CTZ-50

ISSUE 2

INTERNATIONAL CRYSTAL MFG. CO., INC.

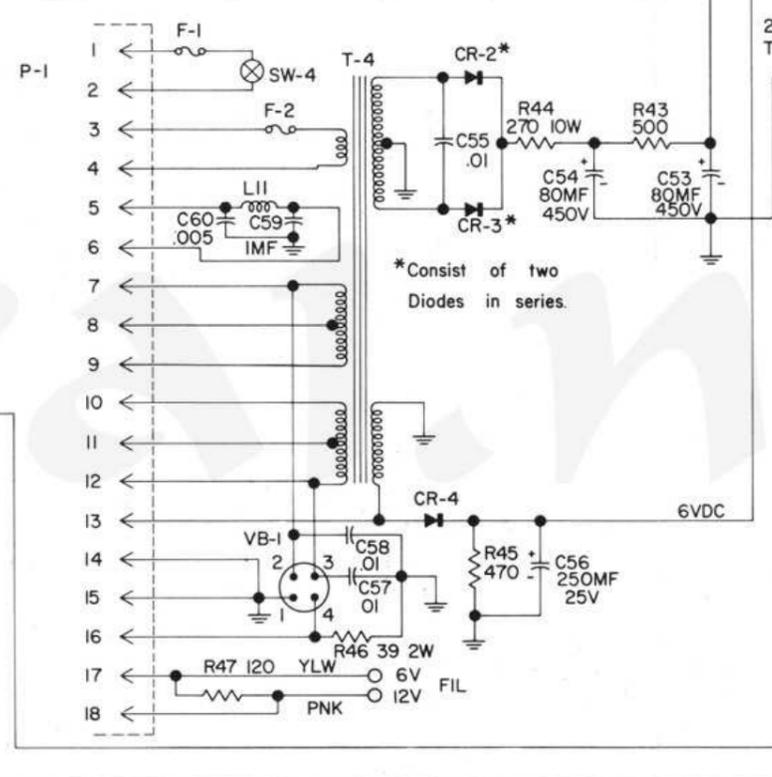
BEGINNING WITH SERIAL NO.	REVISION
7701	C11 CHANGED FROM .02, 500V TO .01, 1000V. 4/26/61
7801	C40 CHANGED FROM 02, 500V TO 02, 1000V. 5/1/61
8269	A 220K, 1/2W RESISTOR CONNECTED FROM PIN 1 OF V9 TO GND. (R57) 5/27/61
8501	C5, C7, C8 & C23 CHANGED FROM 02, 500V TO .005, 500V. L9 CHANGED TO 1500, 1/2 W RESISTOR. (R56) 6/6/61
50373	R16 CHANGED FROM 150K TO 27K. R18 FROM 330K TO 39K. C39 & C42 CONNECTED TO PIN 1 OF V5A. R55 ADDED FROM PIN 1 OF V5A TO GND. R21 CHANGED FROM 68K TO 56K. 10/21/61
